Office Action Summary	Application No. 10/523,851	Applicant(s) FUCHS ET AL.	
	Examiner Jason Daniel Prone	Art Unit 3724

DETAILED ACTION

Figure A:

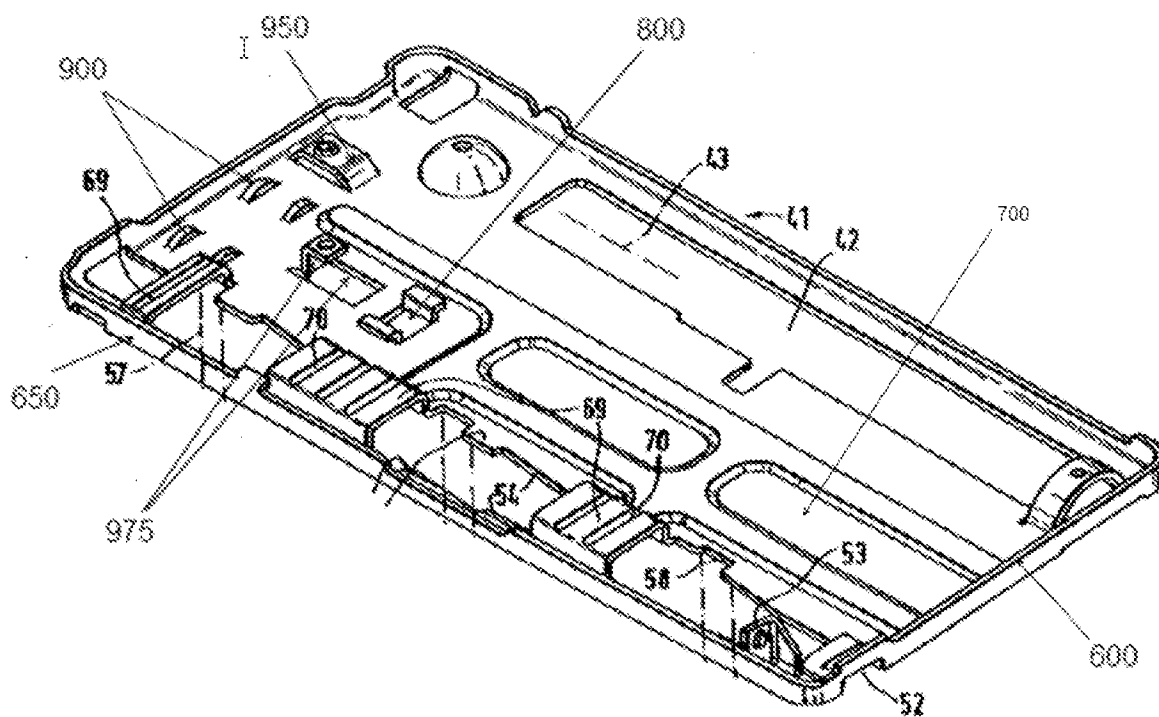
Claims 1-3, 5, 6, and 9 are rejected under 35 U.S.C. 103(a) as being unpatentable over Braunbach et al. (5,678,314) in view of EP 1428636 and Fushiya et al. (D326,399) further in view of Gierke (D363,656). See Figure A below for examiner added reference numerals to Braunbach et al. Braunbach et al. disclose the invention, with regards to claim 1, including a base plate for a circular saw (11) comprised of a metal sheet (Column 5 lines 34-39), a plurality of reinforcing elements that protrude out from a plane of the metal sheet (Fig. 2), at least one of the reinforcing elements is embodied in the form of a lateral stop surface configured as two opposing longitudinal sides of a collar that extends over at least three peripheral sides of the base plate (650), having a row of attaching elements that protrude out from the plane and are capable for fastening the base plate to a miter angle (900), and the metal sheet is configured as a stamped and bent metal sheet (Column 5 lines 34-39), and the entire base plate is embodied in one piece (11).

In regards to claims 6 and 9, Braunbach et al. disclose another of the plurality of reinforcing elements is embodied in the form of a crease (700) and a stamping and bending process (Column 5 lines 34-39).

However, with regards to claims 1 and 3, Braunbach et al. fail to disclose the side connecting the longitudinal sides has a first connecting element, another of the reinforcement elements is configured as an additional collar surrounding an opening for a saw blade and having a second connecting element, the first and second elements are integrated into the base plate and have bores for supporting a pin and defining a rotation axis, and the metal sheet is an aluminum alloy

Figure B:

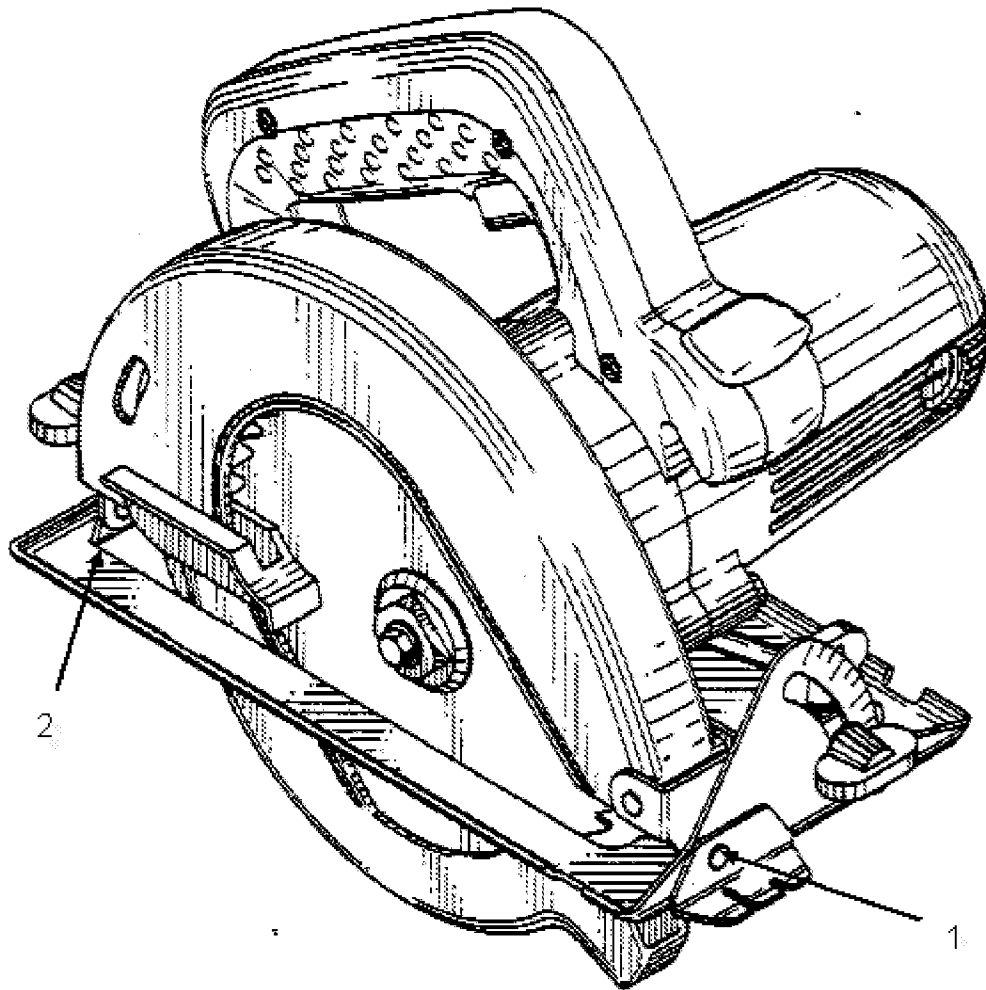
Fushiya et al. (see Figure B) teach it is old and well known in the art of circular saw base plates to incorporate the side connecting the longitudinal sides has a first connecting element (1), second connecting element (2), the first and second elements are integrated into the base plate and have bores for supporting a pin and defining a rotation axis (1, 2). Therefore, it would have been obvious to one of ordinary skill in the art, at the time of the invention, to have provided Braunbach et al. with the connecting elements, as taught by Fushiya et al., to allow the user to adjust the angle of the saw and because all claimed elements were known in the prior art and one skilled in the art could have combined the elements as claimed by known methods with no change in their respective function and the combination would have yielded predictable results.
